**Structural Calculations**  
**Roof Seismic Strengthening - Partial**  
**Concrete Tilt-up Building**  
**1918 E Glenwood Place (Bldg D)**  
**Santa Ana, CA**

## TENANT IMPROVEMENT PLAN CHECK COMMENTS

<b>PLAN CHECK NO:</b>	10173635,6,7		
<b>PROJECT ADDRESS:</b>	1831 S Ritchey St, 1917 E St. Andrews AND 1918 E Glenwood Pl.		
<b>PLAN CHECK ENGINEER:</b>	Kwak, Jason	<b>TEL: 714</b>	647-5866
		<b>FAX: 714</b>	647-5897
<b>TYPE OF CONSTRUCTION:</b>	V B		
<b>OCCUPANCY CLASSIFICATION(S):</b>	B, S-1		
<b>PLAN CHECK DATES:</b>		<b>REMARKS/RECHECK ITEMS:</b>	
<b>APPLICATION</b>	11/7/2011	_____	
<b>INITIAL REVIEW</b>	11/23/2011	_____	
<b>EXPIRATION</b>	5/5/2012	_____	
<b>RECHECKS:</b>	1.	<b>PROJECT APPLICANT CONTACT PERSON:</b>	
	2.	Michael Santillan	
	3.	<b>TEL:</b>	(949)716-9990
<b>VALUATION:</b>	\$30,000.00	<b>FAX:</b>	_____
<b>FLOOD ZONE:</b>	X-0602320277J	<b>EMAIL:</b>	michael.santillan@nationaleng.com

RE: 1918 E. Glenwood Place  
Plan Check # 10173637

**A-1**

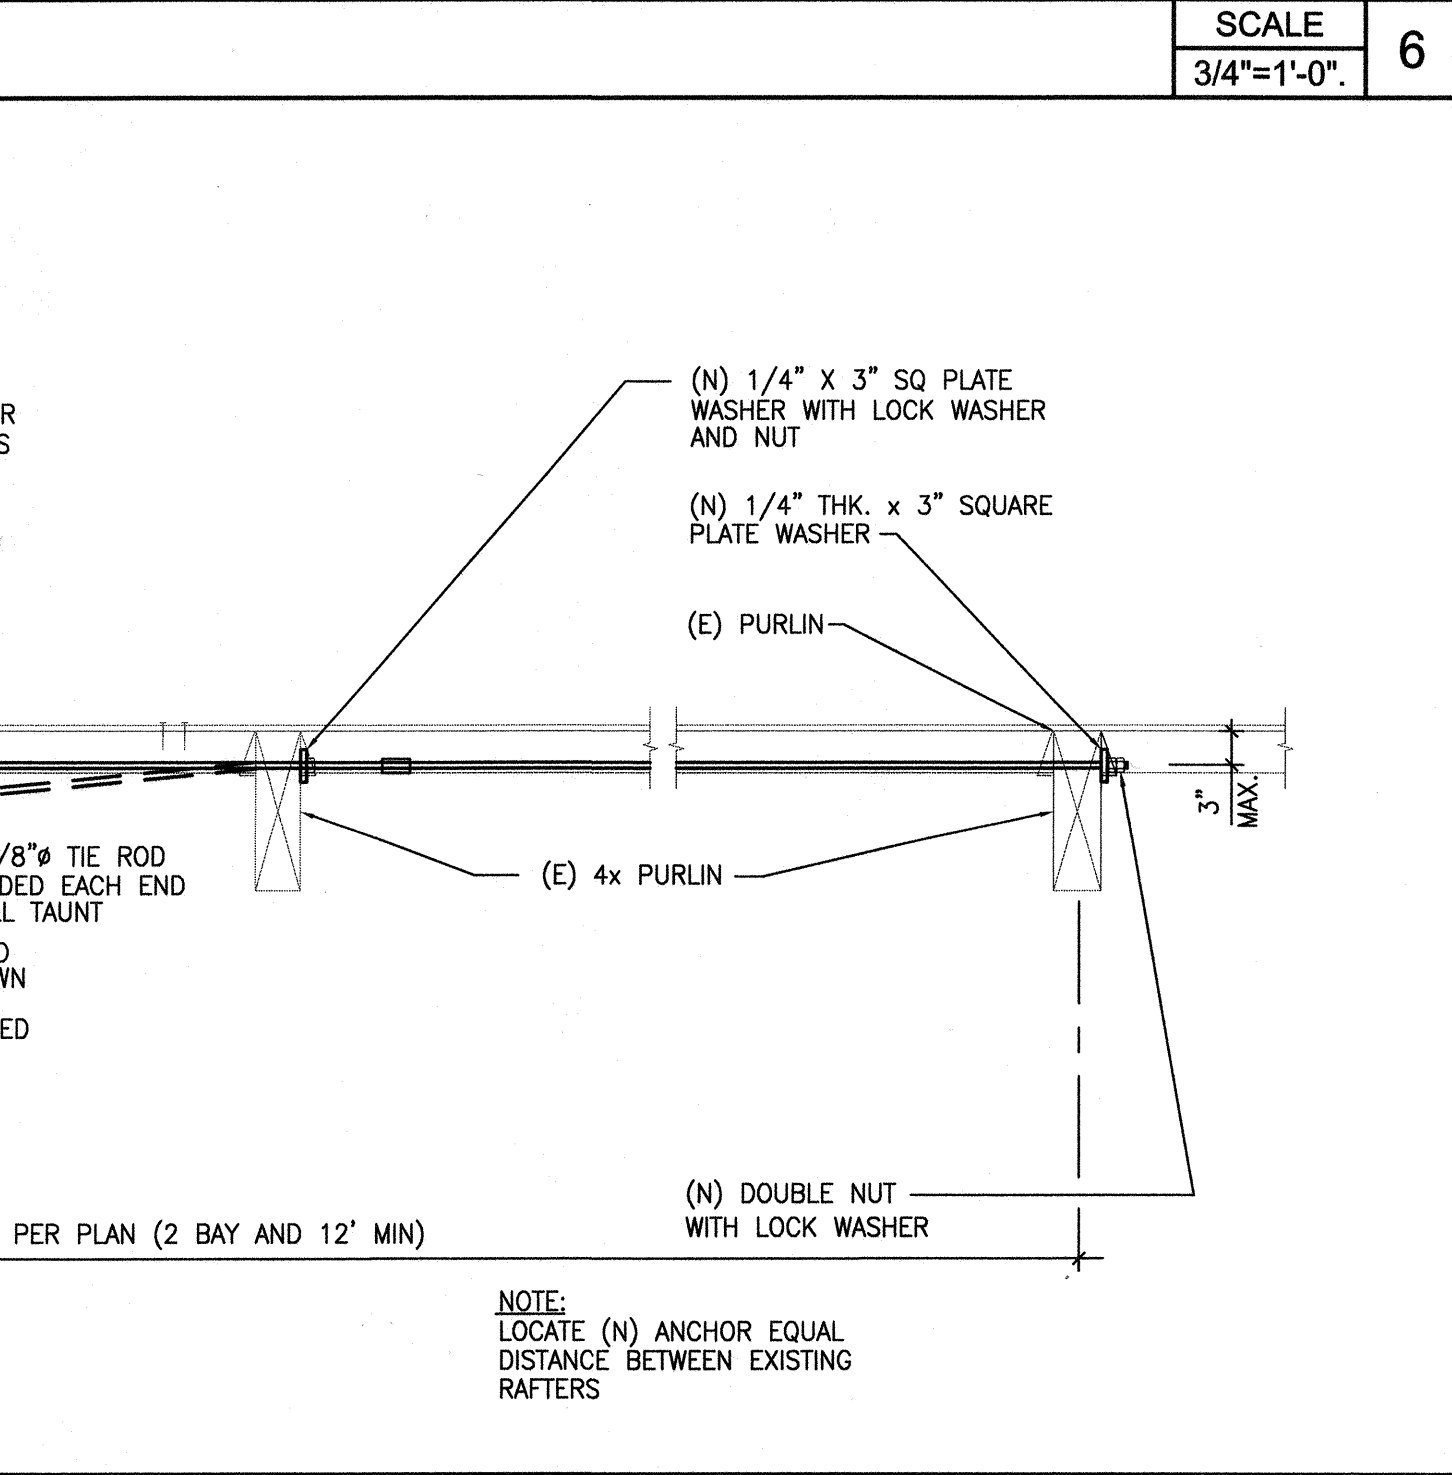
*The drawings/information submitted for Building Safety Division review is incomplete.....-  
Provide required disable accessible upgrade proposal with plans.*

*It is the project designer's/property owner's responsibility to show compliance on the drawings with all applicable Federal and State Accessibility Standards*

*Drawings submitted to the Building Division for review shall provide the following information to insure compliance with CBC Section 1134B/Chapter 11B:*

*Priority shall be given to those elements that will provide the greatest access in the above order.*

**-Response: See sheet A-1, which shows proposed ADA upgrades**

**-Response: Proposed ADA upgrades are now shown on the new sheet A-1**

**-Response: see sheet A-1**

**-Response: see sheet A-1**
